Title - Sujet High Density Mobile Shelves Rayonnages mobiles haute densité	
Solicitation No. - N° de l'invitation M5000-213205/A	Amendment No. - N° modif. 003
Client Reference No. - N° de référence du client M5000-213205	Date 2021-03-01
GETS Reference No. - N° de référence de SEAG PW-\$CAL-146-7174	
File No. - N° de dossier CAL-0-43181 (146)	CCC No./N° CCC - FMS No./N° VME
Solicitation Closes - L'invitation prend fin at - à 02:00 PM Mountain Standard Time MST on - le 2021-03-09 Heure Normale des Rocheuses HNR	
F.O.B. - F.A.B.	
Plant-Usine: <input type="checkbox"/> Destination: <input checked="" type="checkbox"/> Other-Autre: <input type="checkbox"/>	
Address Enquiries to: - Adresser toutes questions à: Abou Ahmad, Kassan	Buyer Id - Id de l'acheteur cal146
Telephone No. - N° de téléphone (403) 464-9492 ()	FAX No. - N° de FAX (418) 566-6167
Destination - of Goods, Services, and Construction: Destination - des biens, services et construction:

This amendment 003 is raised to answer the following questions from industry, extend the closing date and amend Solicitation M5000-213205/A as follows:

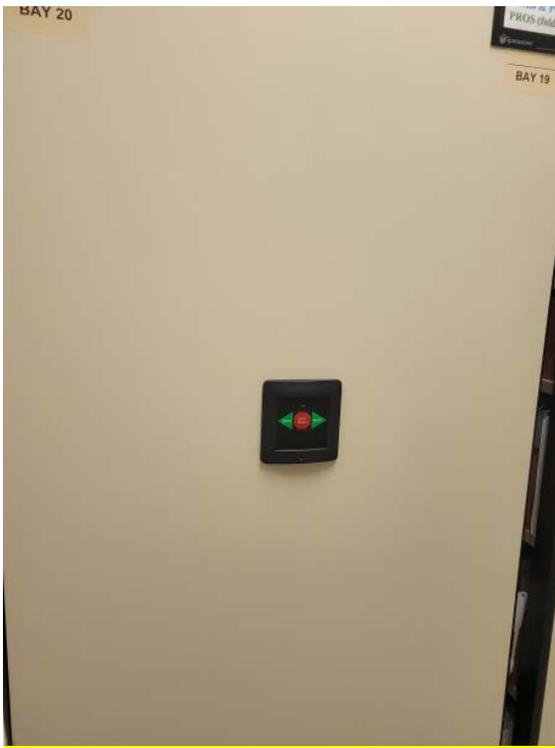
Question 1:

Is there an opportunity for a site visit if COVID-19 protocols are followed?

This is what one bay of shelves looks like. A shelf 15 inches on both sides of the bay.

This is what the shelf depth is 15 inches and on the other side is another shelf that is 15 inches.

Due to Covid 19 we are trying to limit site visits to government buildings. However, we can provide photos to show the track, carriages, front panels, existing safety components and the shelving. Please see photos below;

There is one shelf on either side of the bay in all cases. Please refer to the pictures above in question one (1)
